Transportation Advisory Board Special Meeting

- b. **Driveway Ordinance Discussion and Comments**

**MATANUSKA-SUSITNA BOROUGH
TRANSPORTATION ADVISORY BOARD
RESOLUTION NO. TAB 20-02**

**MATANUSKA-SUSITNA BOROUGH
ORDINANCE SERIAL NO. 20-____**

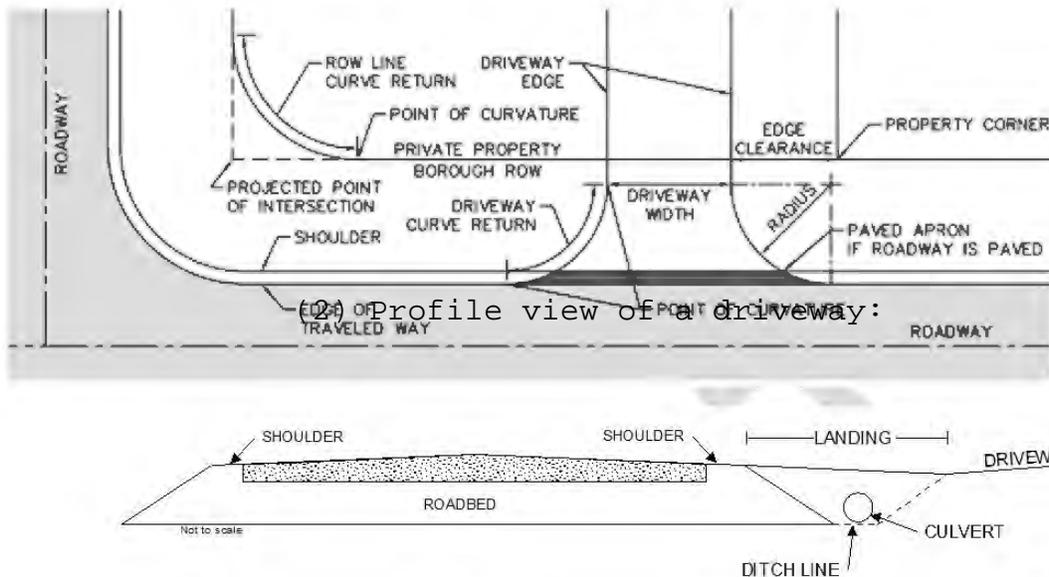
How do these mesh with A03 of the new SCM? Where are these classifications defined?

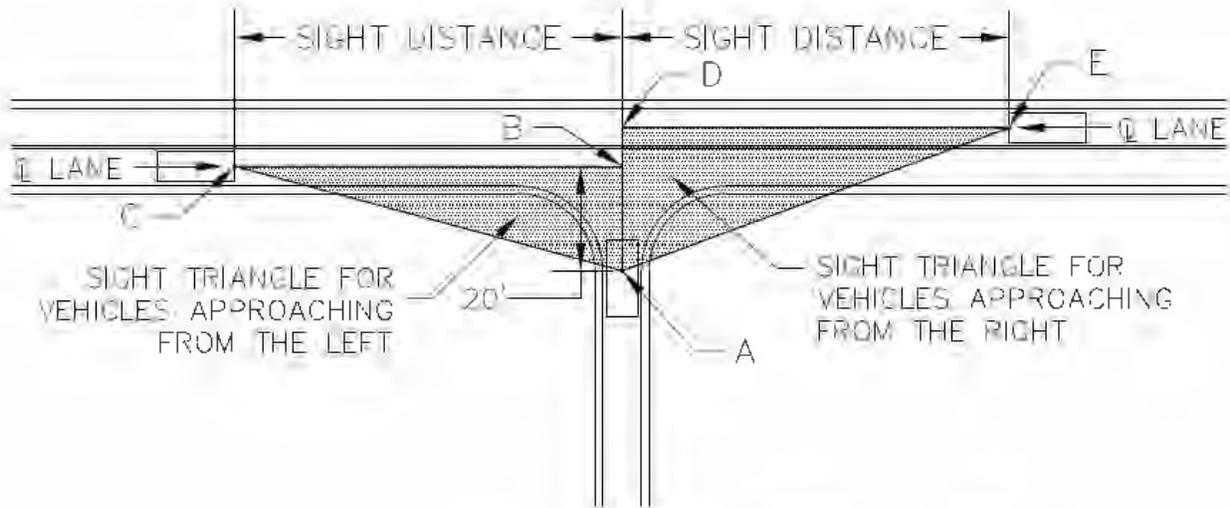
(b) culverts shall be sloped to match the ditch gradient at a minimum of 0.5 percent in the direction of flow; and **maximum gradient needed?**

(a) The entire area of the sight triangles shown in the **below?** **above** figure shall be designed to provide a largely unobstructed view from point A at 3.5 feet above the roadway to all points 3.5 feet above the roadway along the lane centerlines from point B to point
